DEVELOPMENT DETERMINATION PANEL MEETING

WEDNESDAY 26 JUNE 2024

**ITEM 3.1 DA2023/0803 - 287 MONA VALE ROAD TERREY HILLS -
ALTERATIONS AND ADDITIONS TO THE EXISTING HILLS FLOWER
MARKET SITE**

DEVELOPMENT APPLICATION ASSESSMENT REPORT

Figure 3. Southern boundary side setback non-compliance

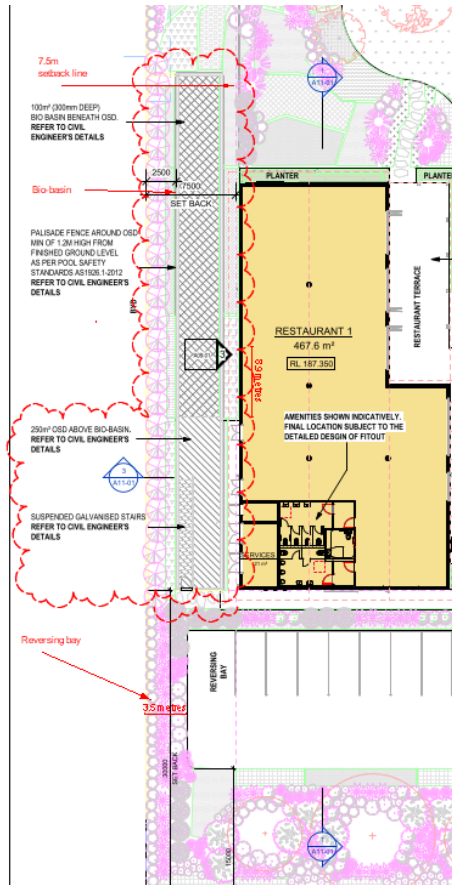
In addition, the proposed at-grade reversing bay provides a minimum southern side setback of 3.5m.

The figure below indicates the areas of non-compliance.

Figure 4. Rear setback non-compliance

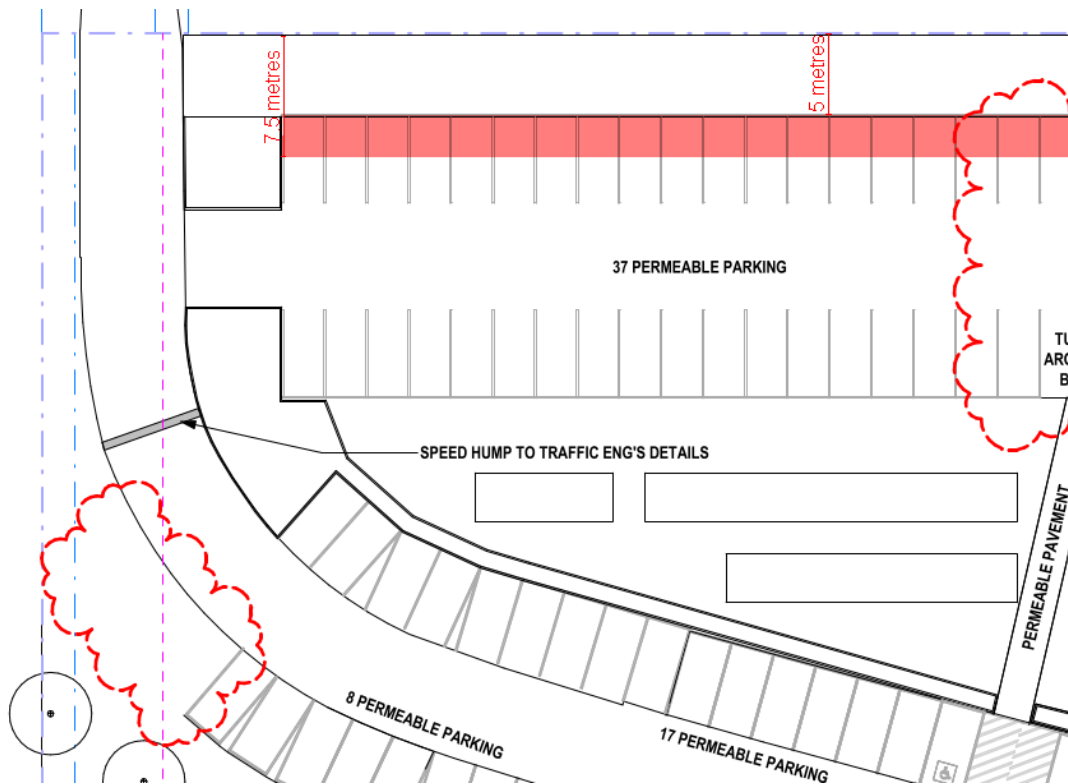
The proposed permeable parking area provides a minimum rear setback of 5.5m. The control requires a minimum rear setback 7.5m.

The non-compliance is diagrammatically displayed below:

Figure 1. Extract of Section 1 (red highlighting height of buildings variation)

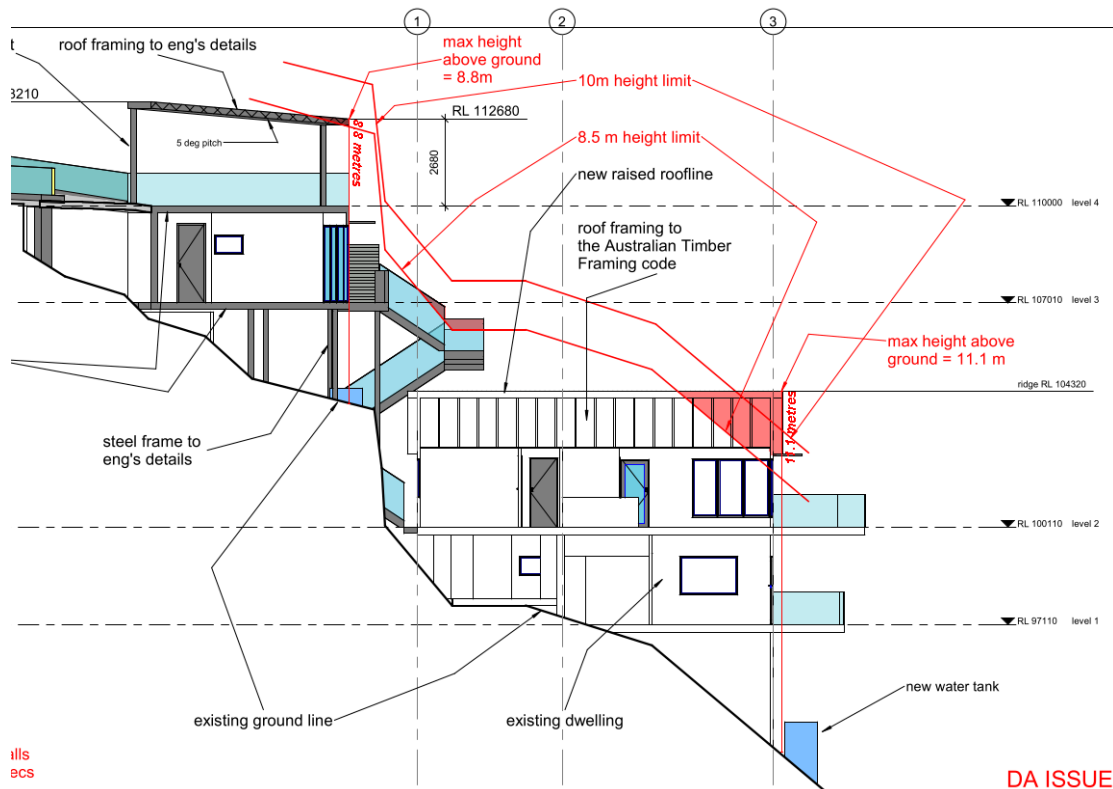
Percentage of variation: 30%

The proposed variation sought is detailed in Figure 1. It is important to note, that the main variation sought is resultant of the existing roof form at the site and the breach is due to the roof being replaced.

Figure 2. North Elevation (red shading highlighting numerical building envelope non-compliance)

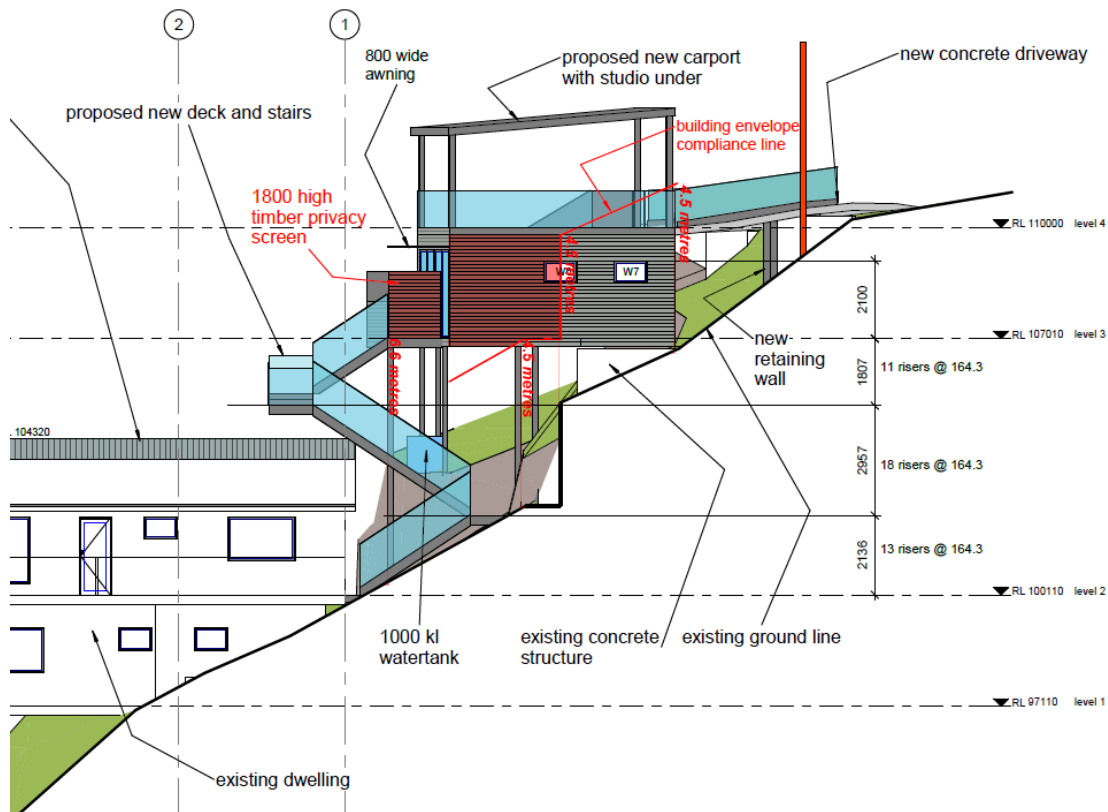
Under Clause D10.11 Building envelope of Pittwater 21 DCP, buildings are to be sited within the following envelope determined by planes projected at 45 degrees from a height of 3.5m above ground level (existing) at the side boundaries to the maximum building height.

The northern elevation of the proposal sits outside of the building envelope.

The extent of the envelope breach is shown in the Figure 2 below.

Figure 3: Section drawing showing extent of height breach. **Source:** Peter Downes Designs **Annotation in green:** Blackwattle Planning

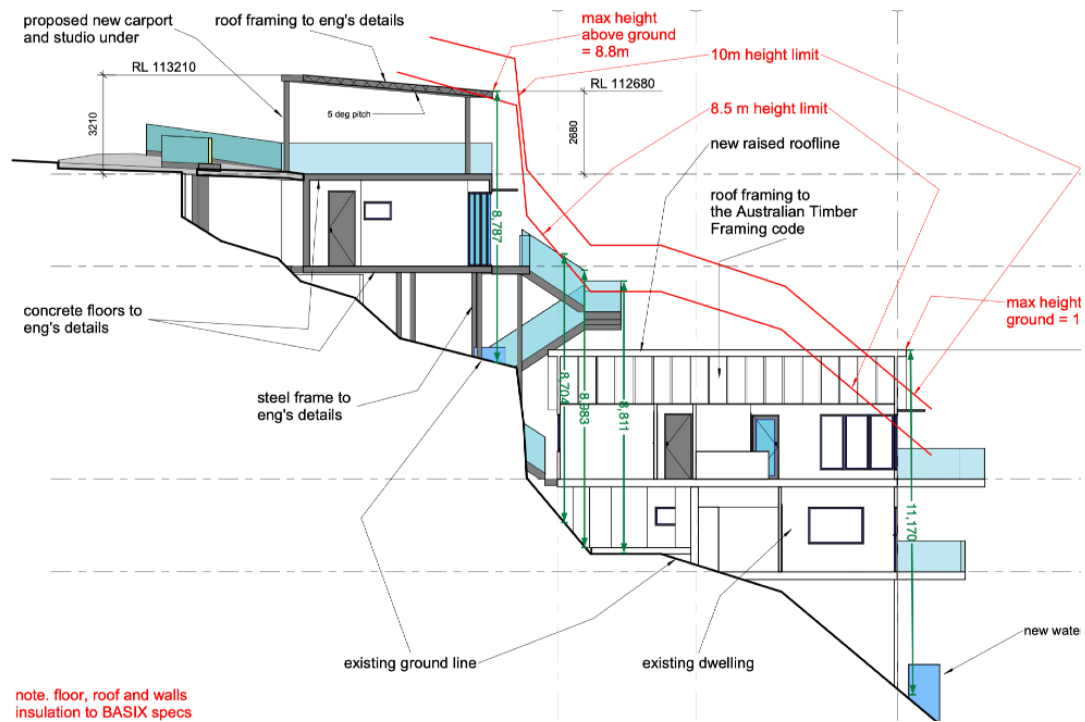
The Section drawing included below (Figure 3) sets out the various points at which the proposed development breaches the 8.5m height limit. The ground line has been drawn as *ground level existing* as defined in PLEP 2014, which follows the existing ground lines on the site, and including the excavated ground level within the footprint of the existing dwelling.

The highest point of the proposed extension to the existing roof of the dwelling is 11.1m - a 30% variation.

The balustrade of the access stairs which extend over the excavated footprint of the existing dwelling have variable height of between 8.7m - 9m above ground level existing - a 2.4 - 11% variation.

Figure 1. Building height non-compliance.

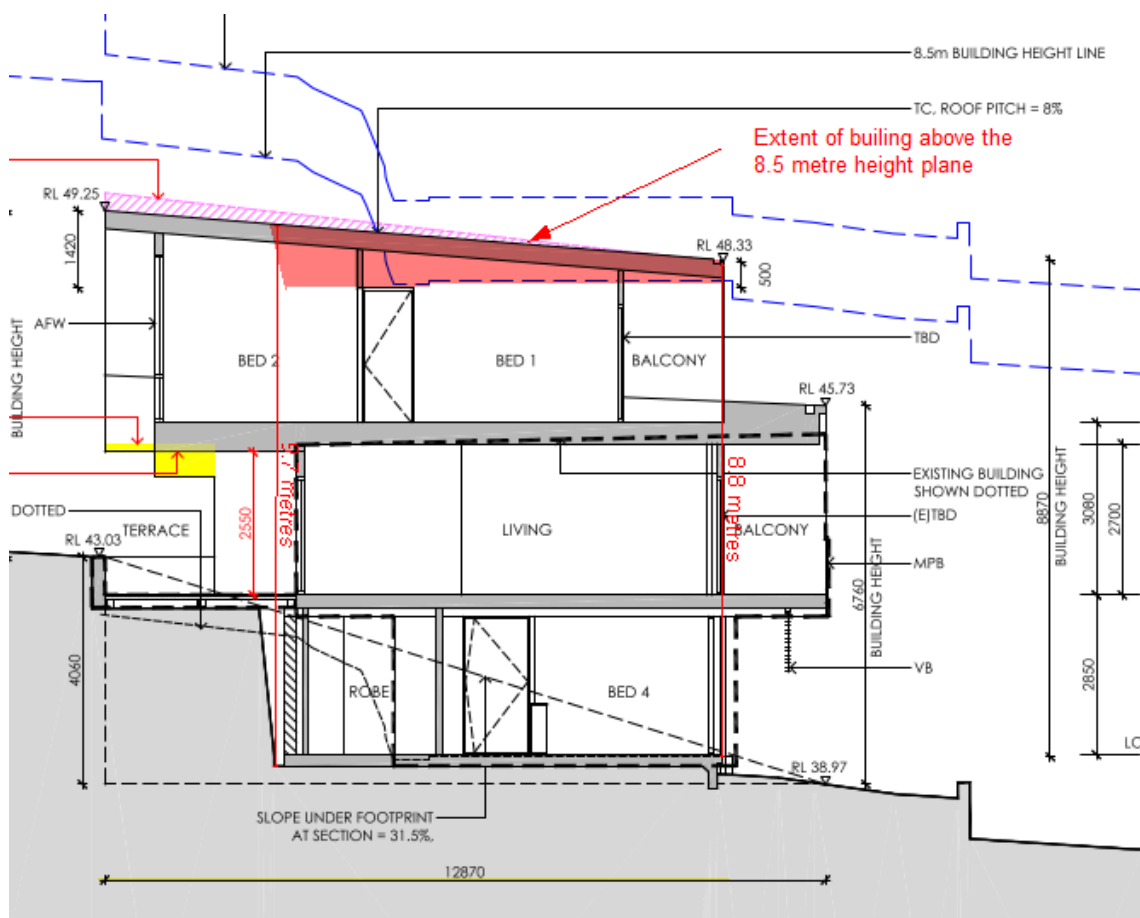
4.3 Height of buildings**Description of Non-compliance**

Development standard:	Height of buildings
Requirement:	8.5m
Proposed:	9.7m
Percentage variation to requirement:	11.7%

Figure 2. Comparison of the proposed v approved building's planar/latitudinal extent beyond the 8.5m standard.

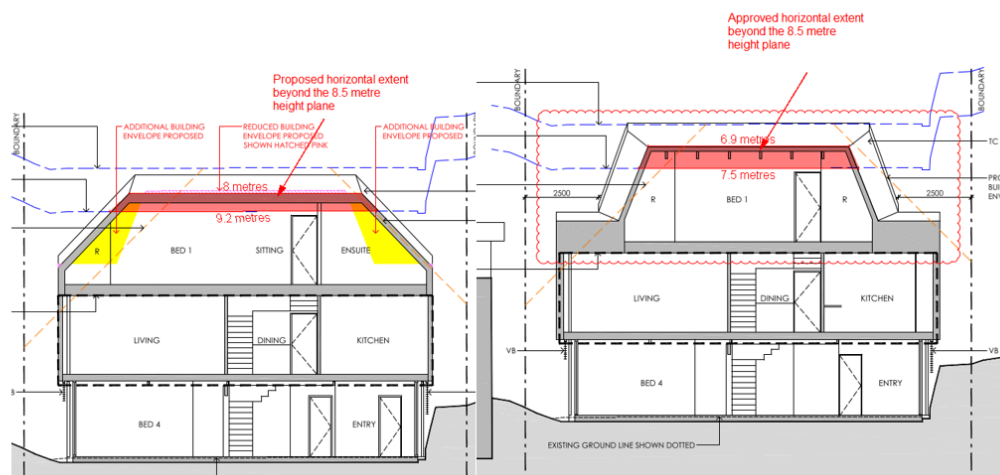
However, the proposed modifications to Level 1 would significantly increase the building's horizontal extent beyond the 8.5m height plane, resulting in excessive bulk and scale that is inconsistent with the desired local character. This is illustrated diagrammatically below:

Therefore, the portion of the modified building above the maximum height is not considered minor and does not meet the relevant criteria under subclause 2D of the height of buildings control within PLEP 2014. Consequently, for the purpose of this assessment, the modified proposal is evaluated against the 8.5m standard.

Figure 8. Proposed envelope non-compliance. Additional envelope breach on the elevations shown in green, existing/approved envelope breach shown in red. Roof plan - Envelope breach shown in

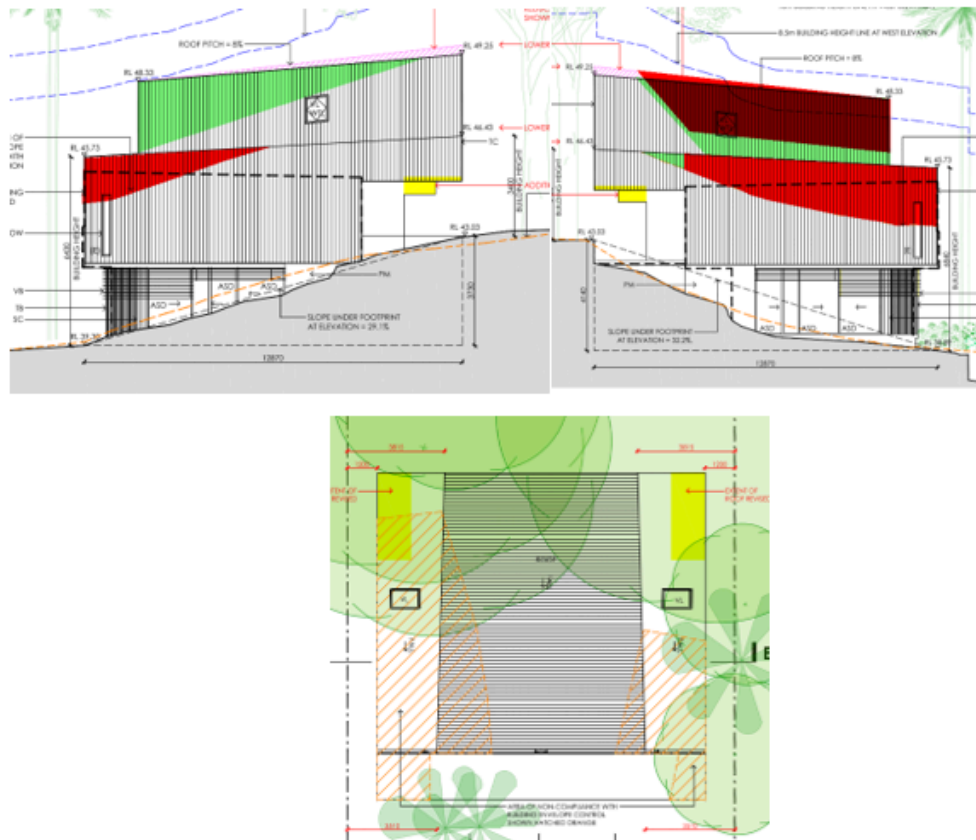
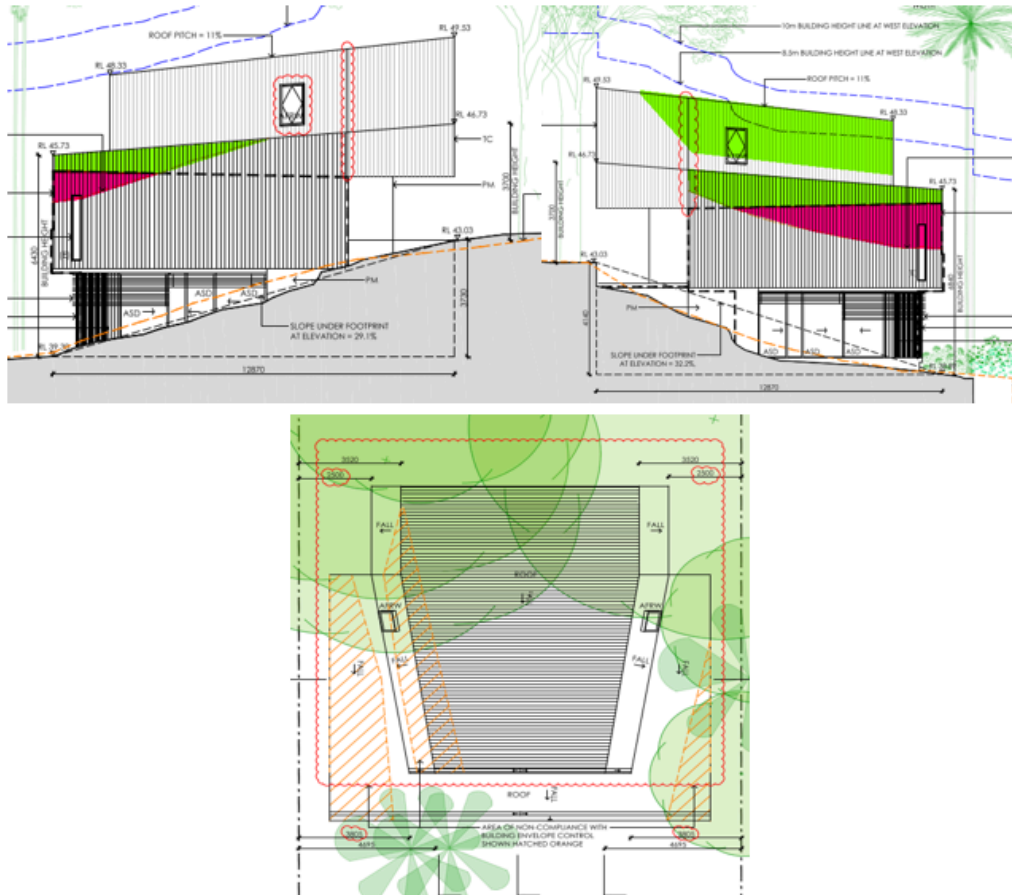
The modified breaches of the building envelope control at the eastern and western elevations are indicated on the below Figures.
